THE MARYLAND ZOO IN BALTIMORE

PERIMETER GATE REPORT

SEPTEMBER 2021

#28 MARYLAND WILDERNESS/PARKDALE ROAD GATE

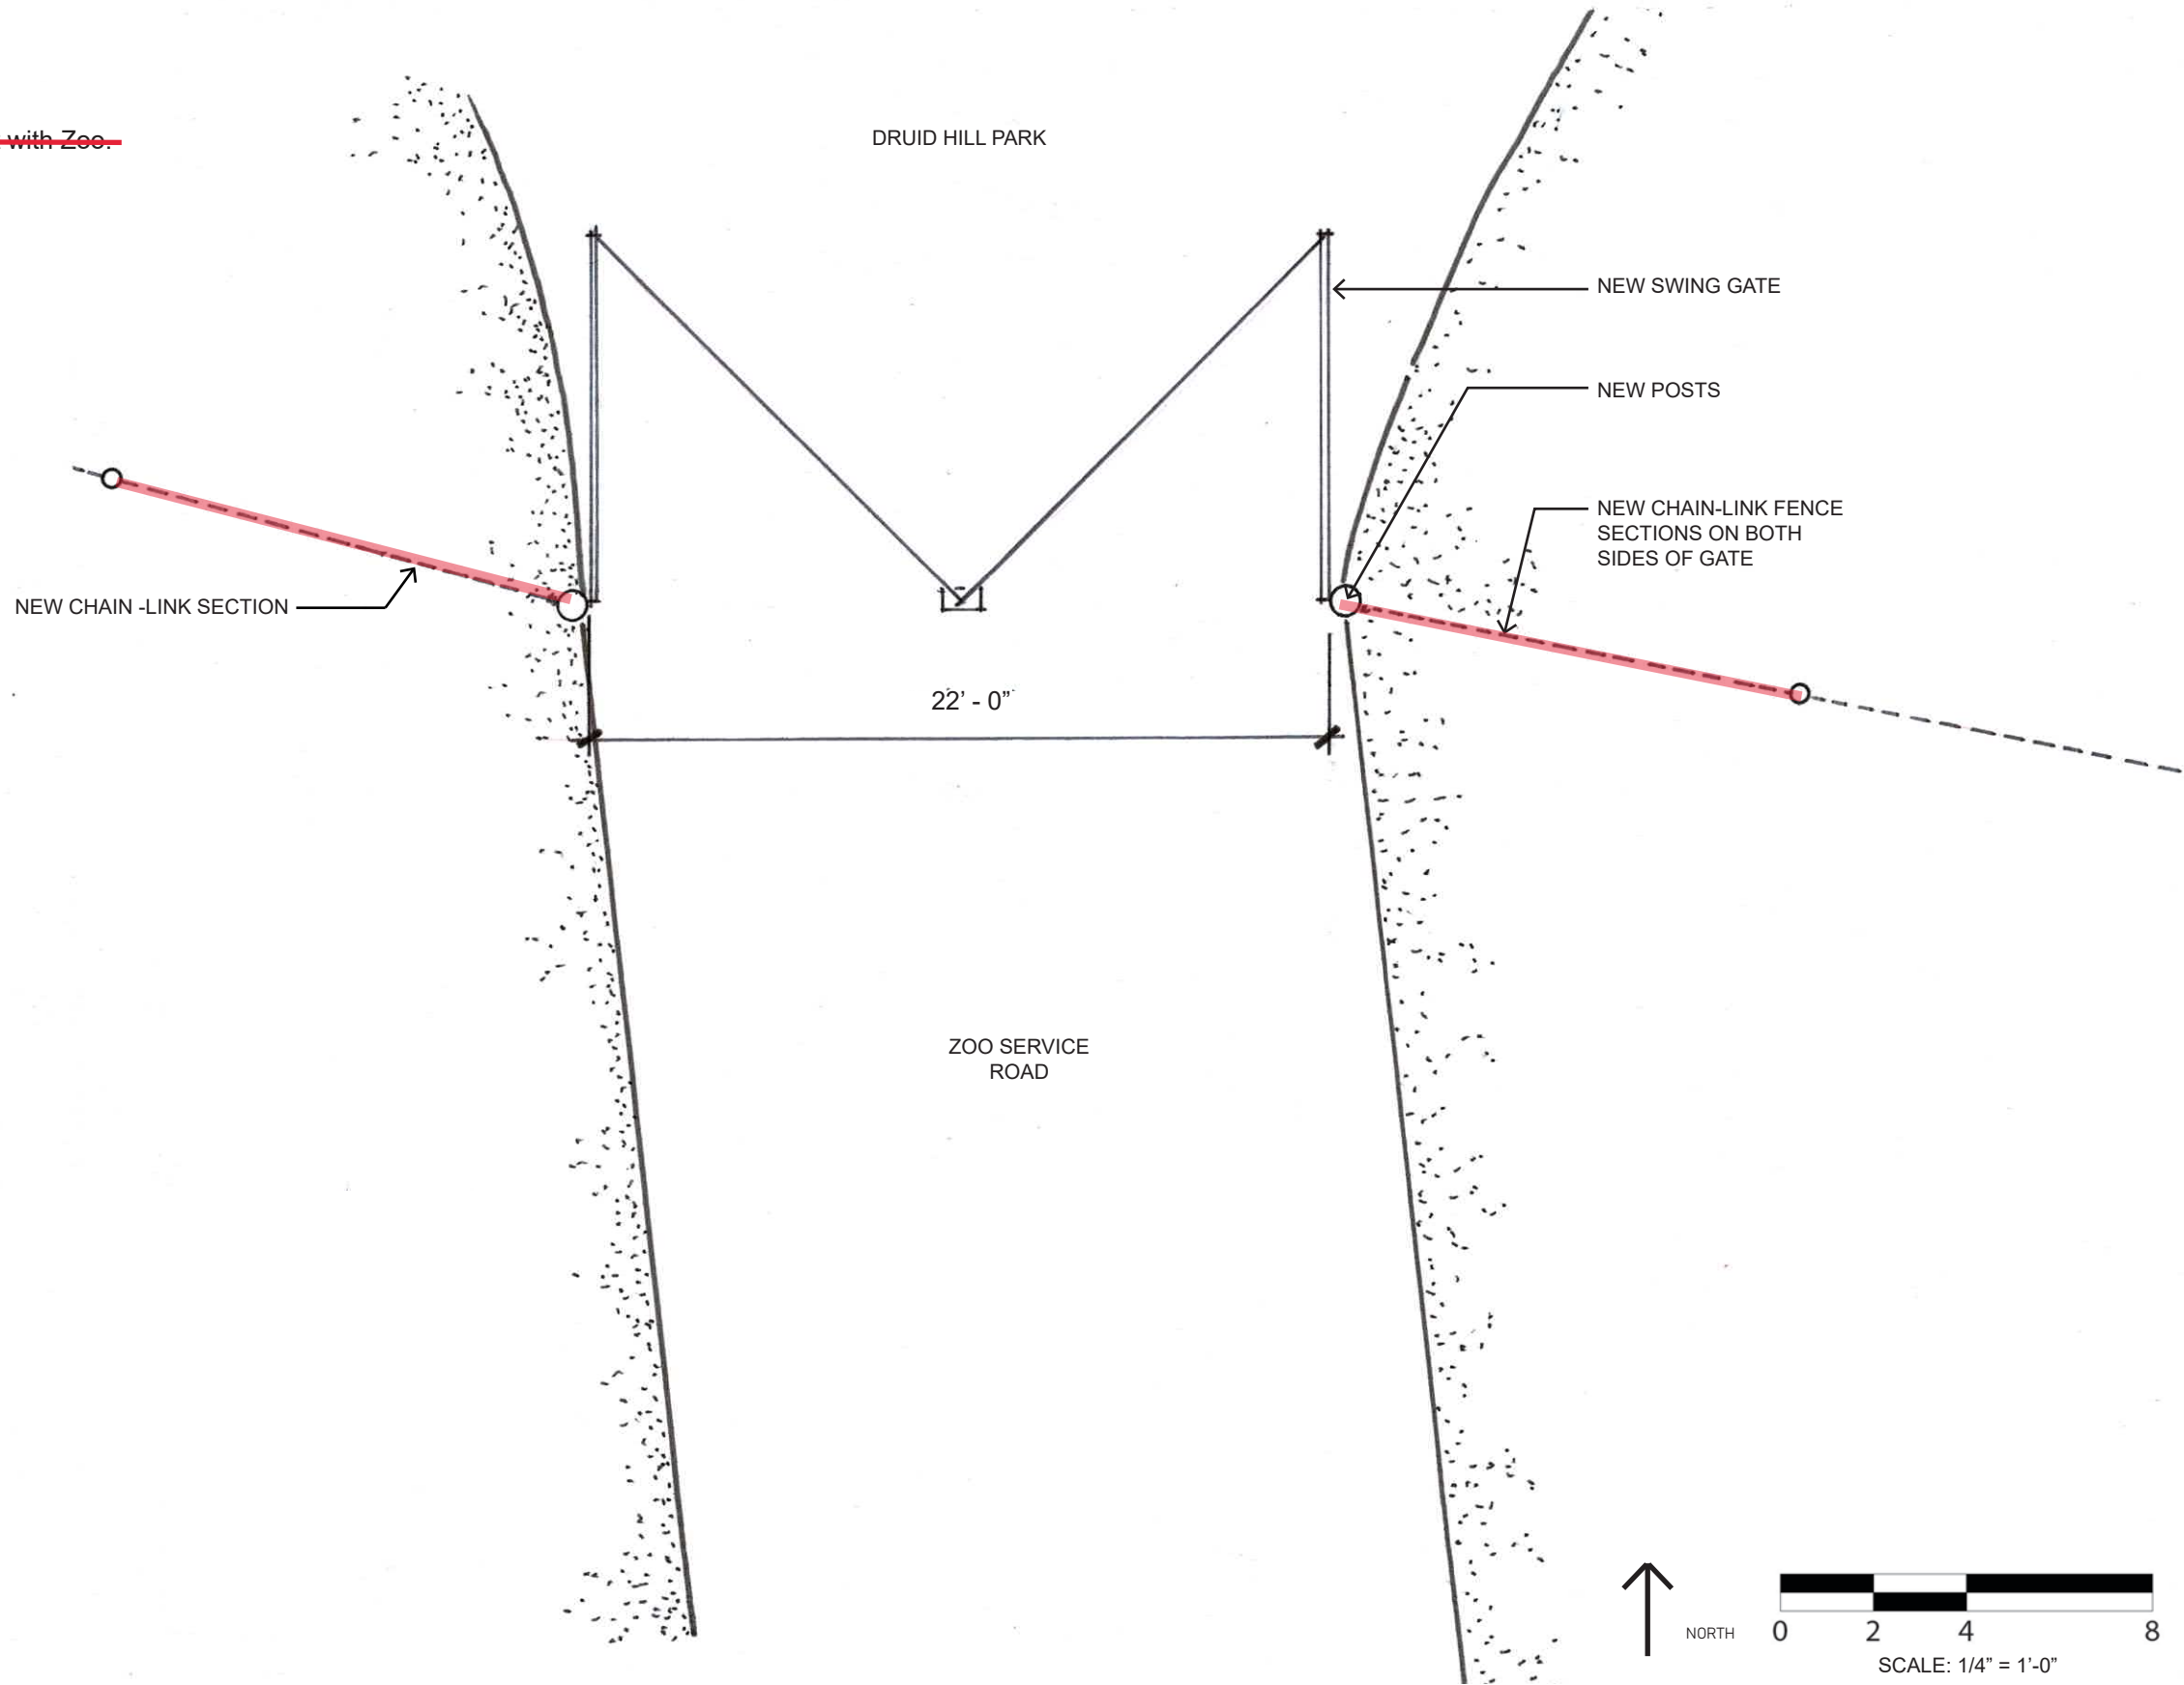
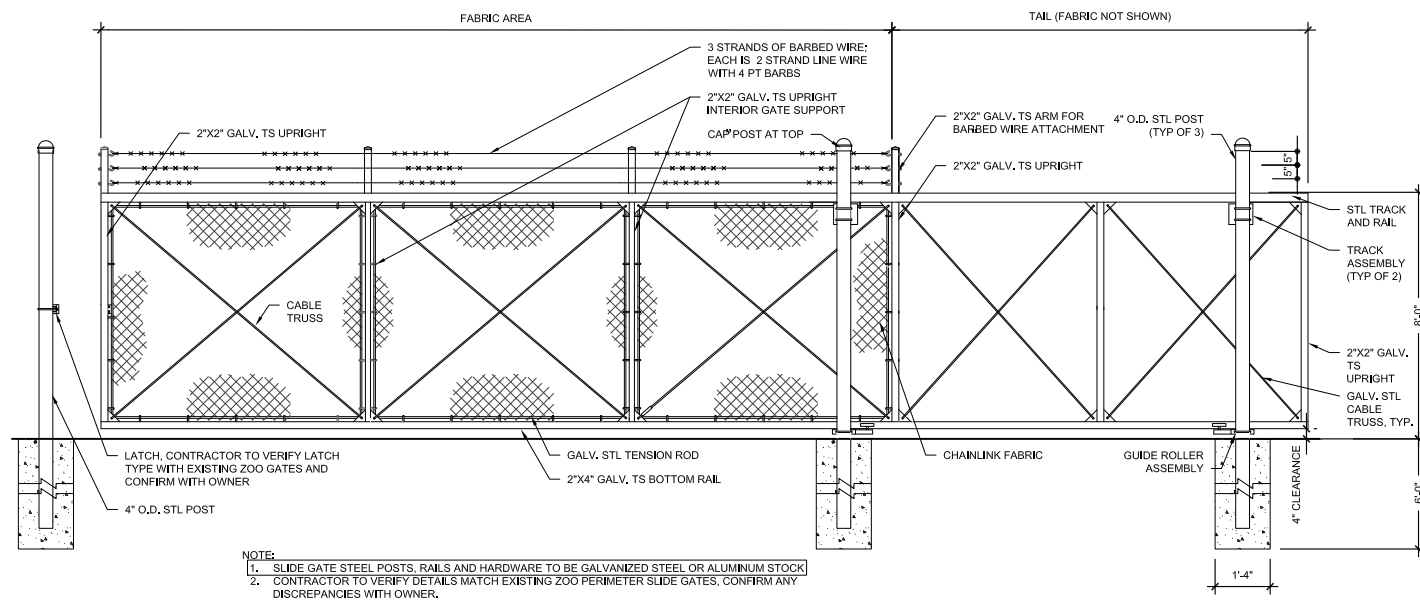
- ~~New sign to match "New Zoo Standard" coordinate text with Zoo.~~
- New 22 ft black vinyl coated manual swing gate.
- Remove existing concrete footers.
- Patch asphalt where needed.
